# Review of GeoScience's Groundwater Extraction Simulations for the Proposed CalAm Monterey Peninsula Water Supply Project

Preston Jordan, Christine Doughty,  
and Curt Oldenburg

1 September 2016

# FO-SVA Below Water Level Conceptual Model

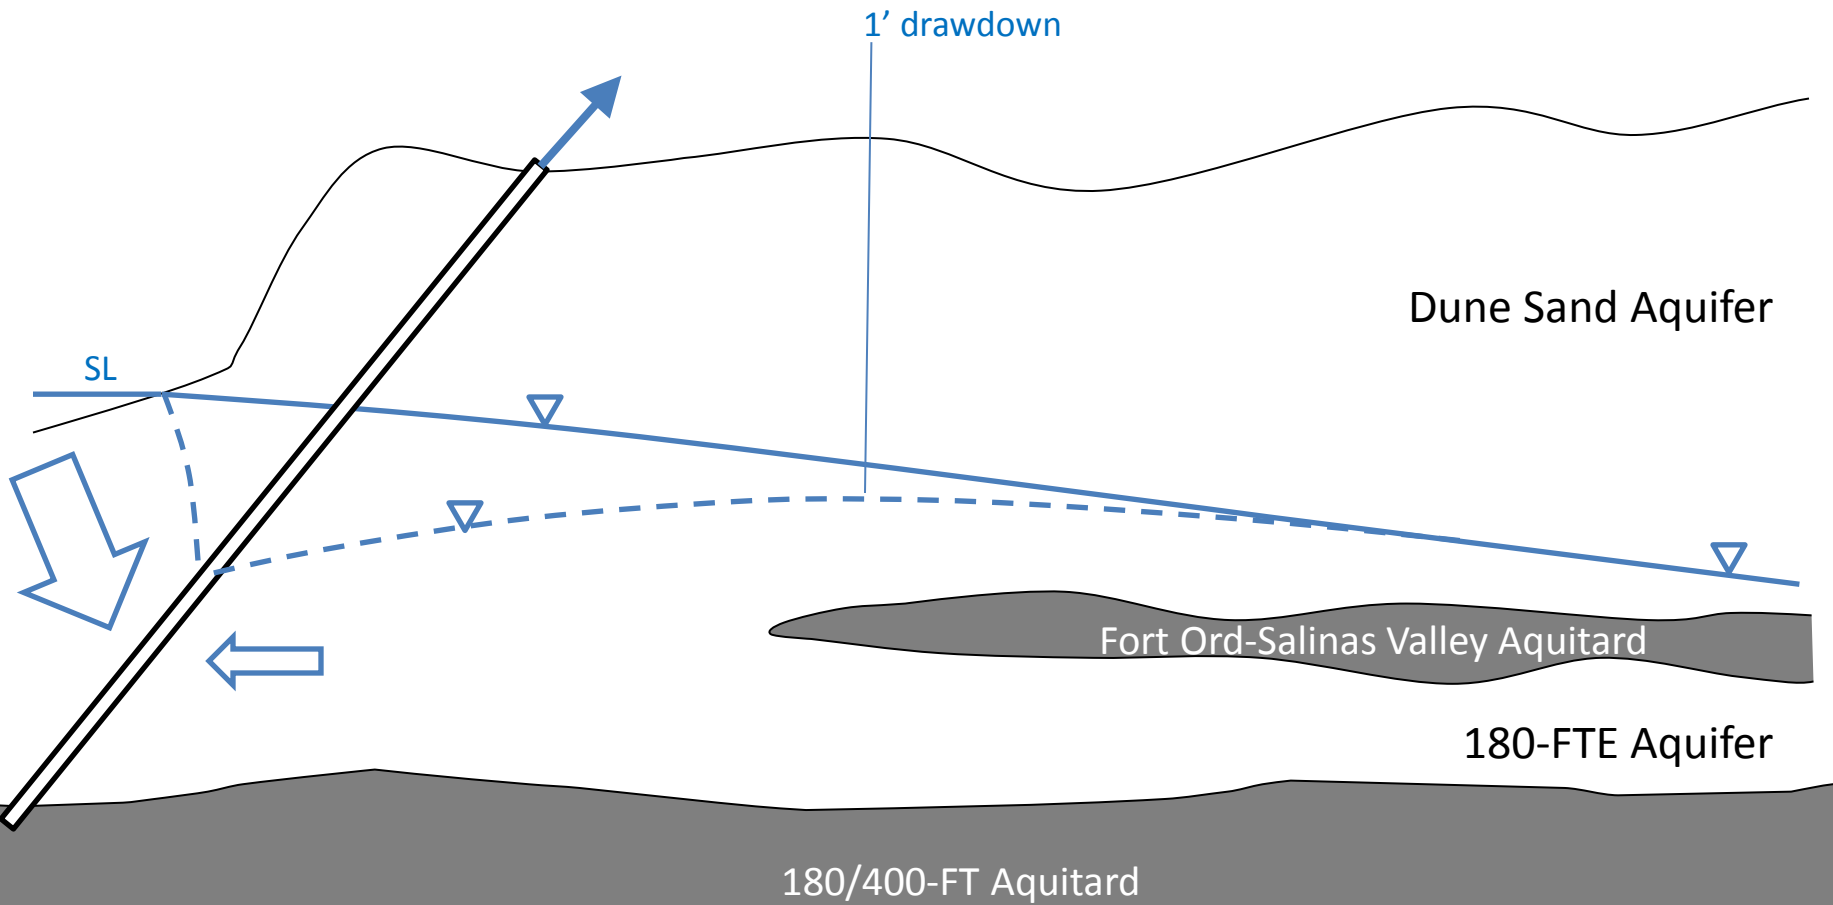
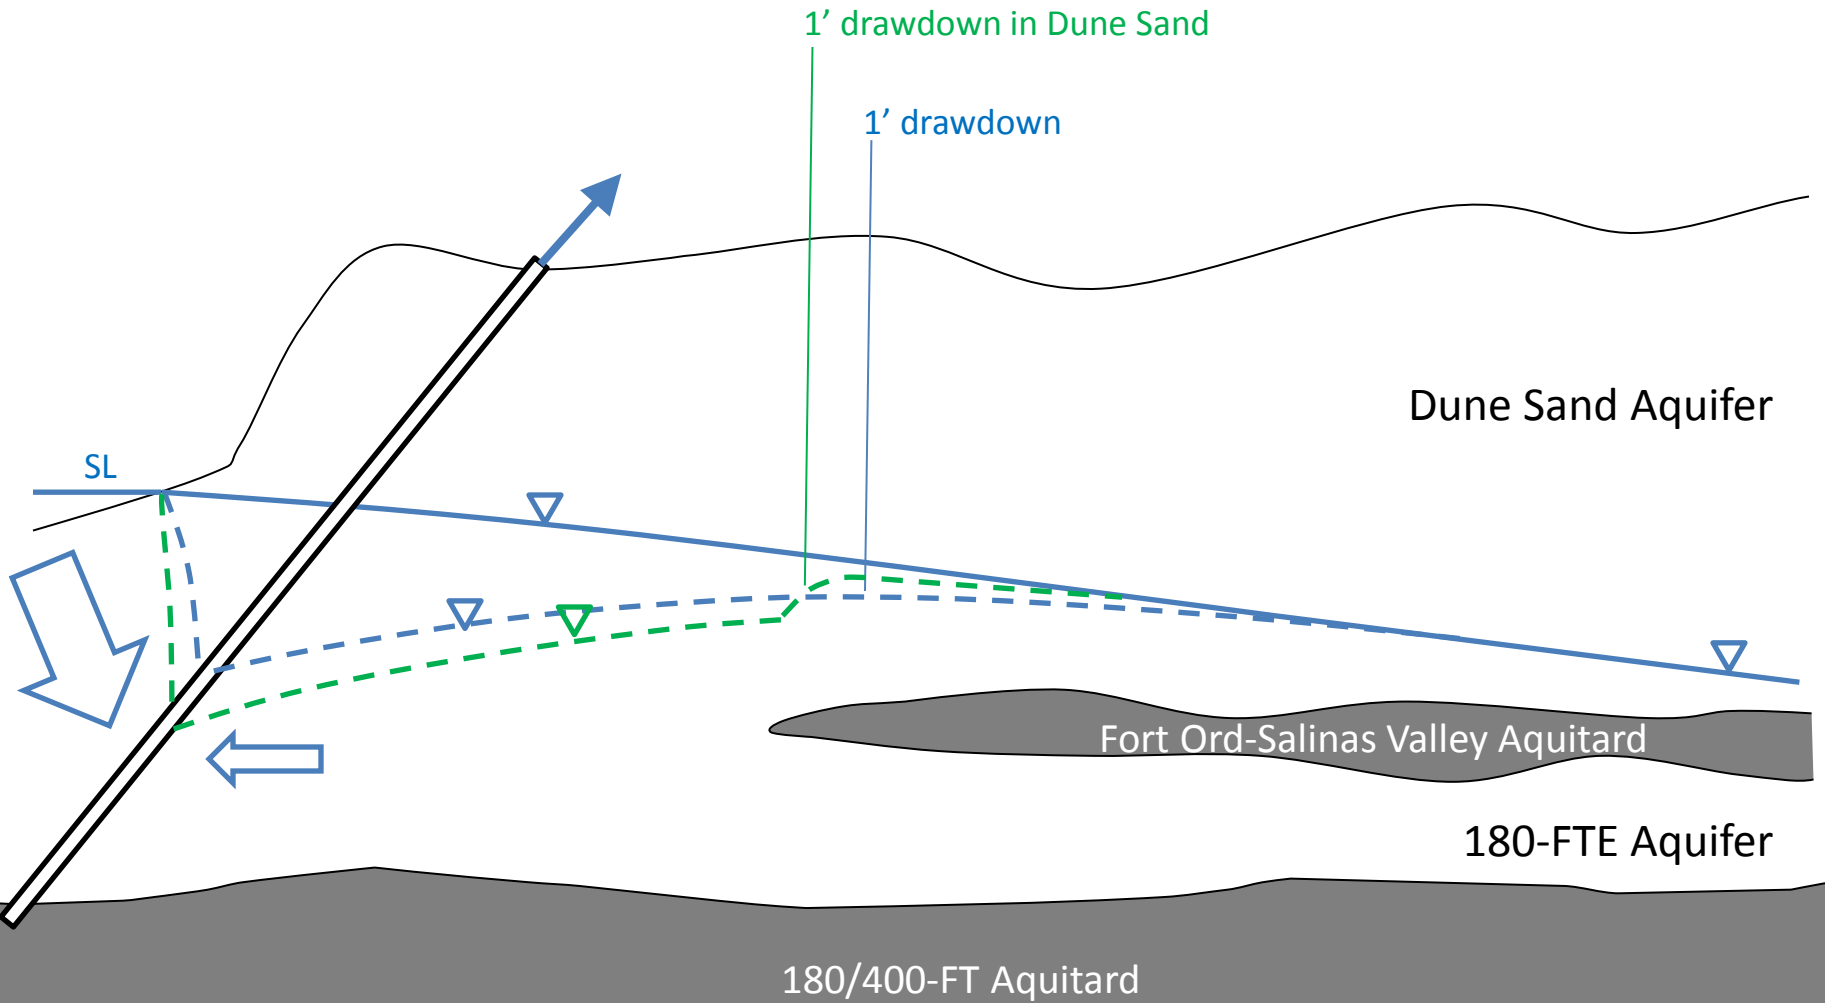
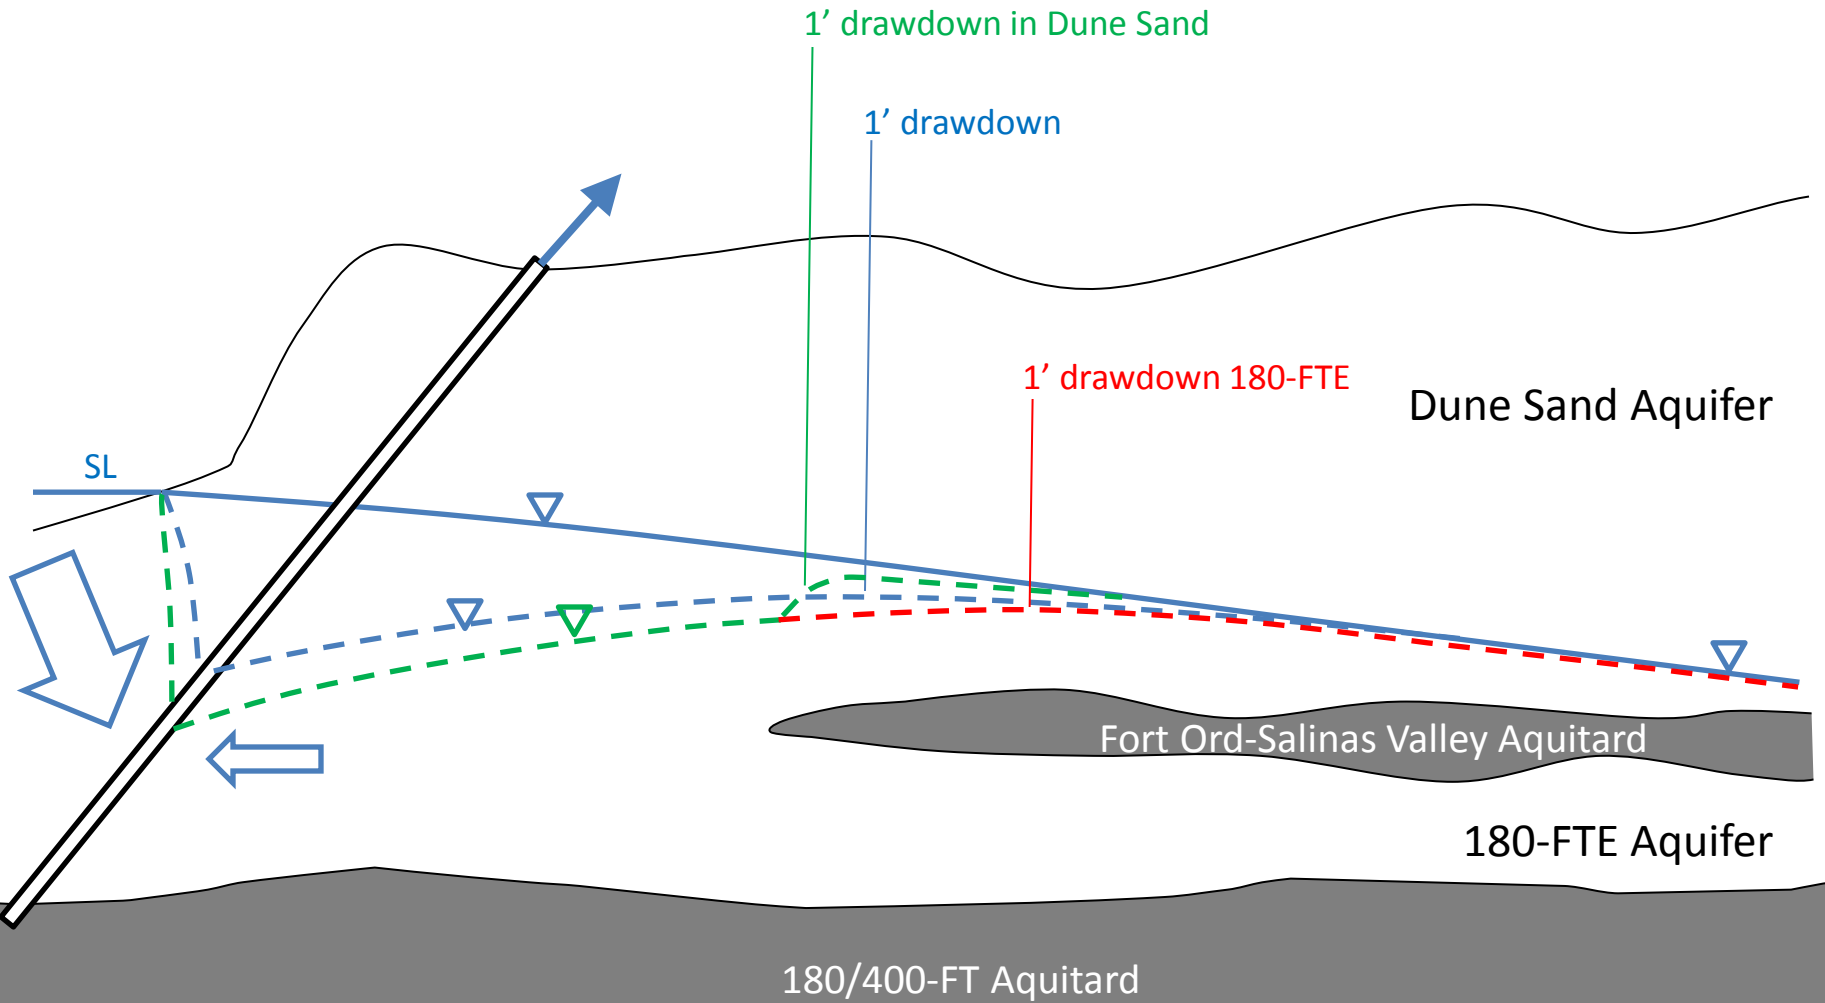
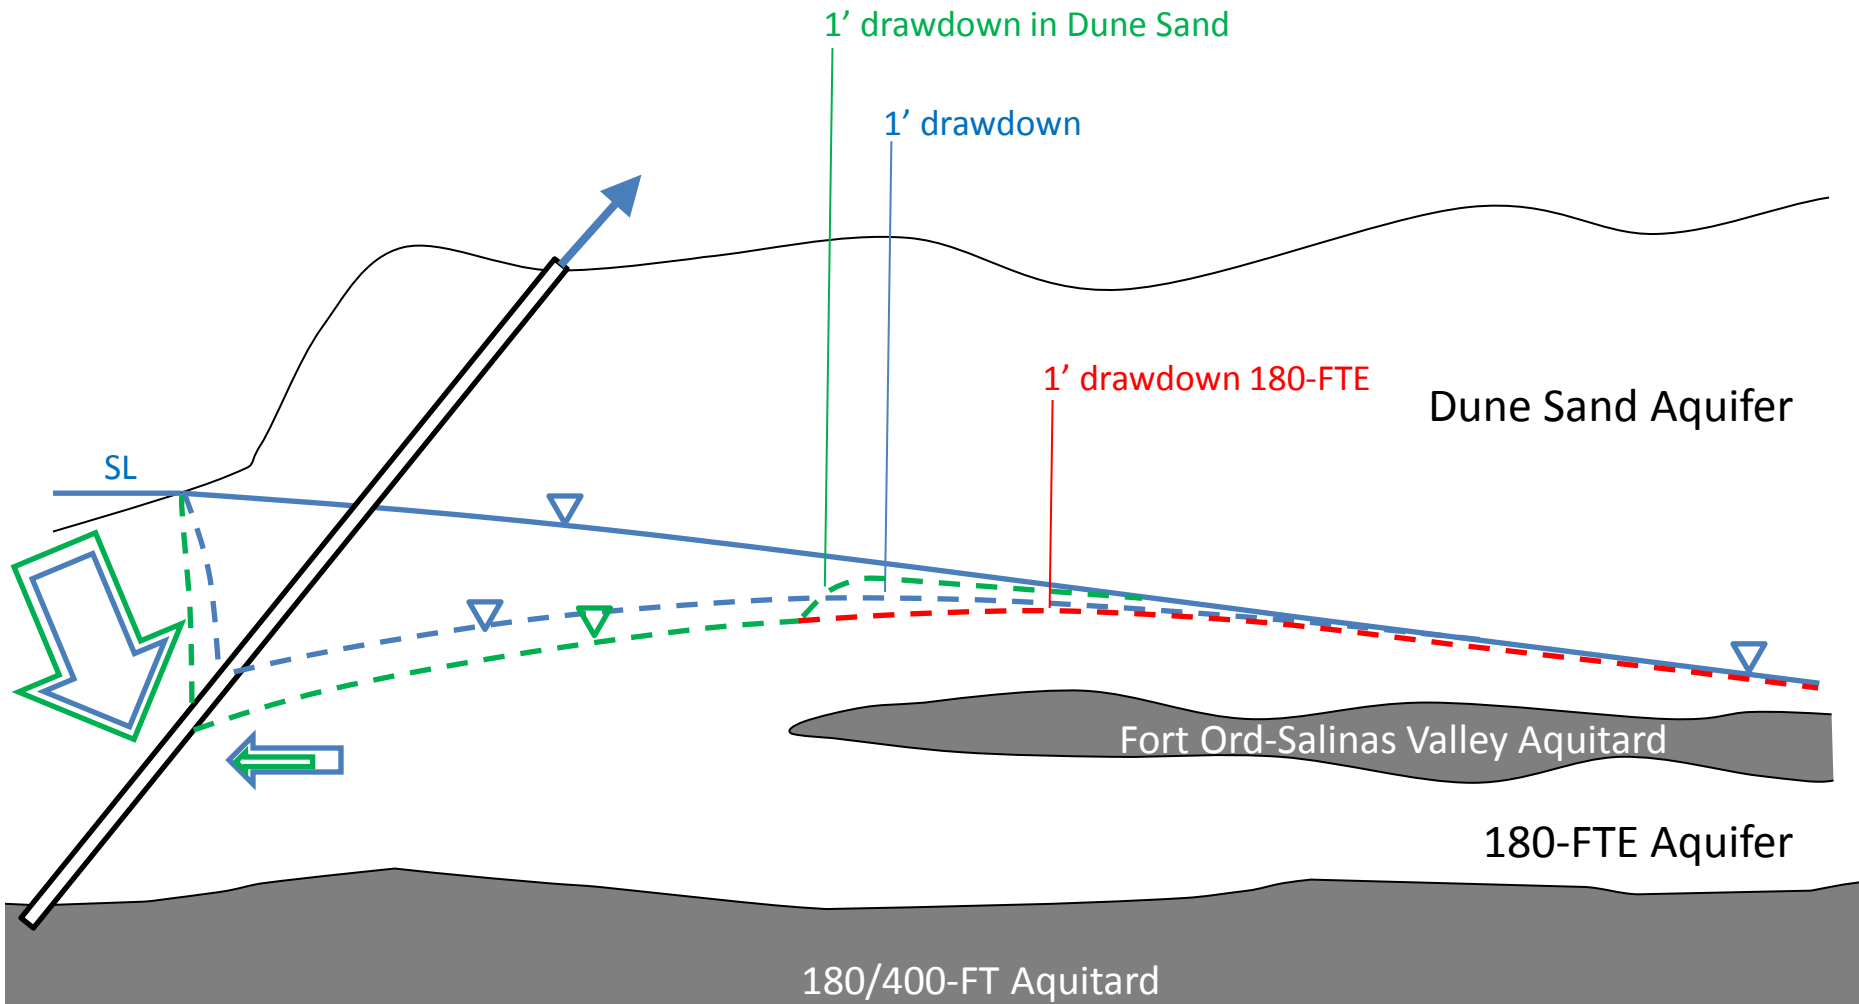
- Groundwater simulation outputs verified using same inputs and same models
- Hydrostratigraphic model deficient due to absence of Fort Ord-Salinas Valley Aquitard
- Aquifer hydraulic conductivities input to simulations are too large
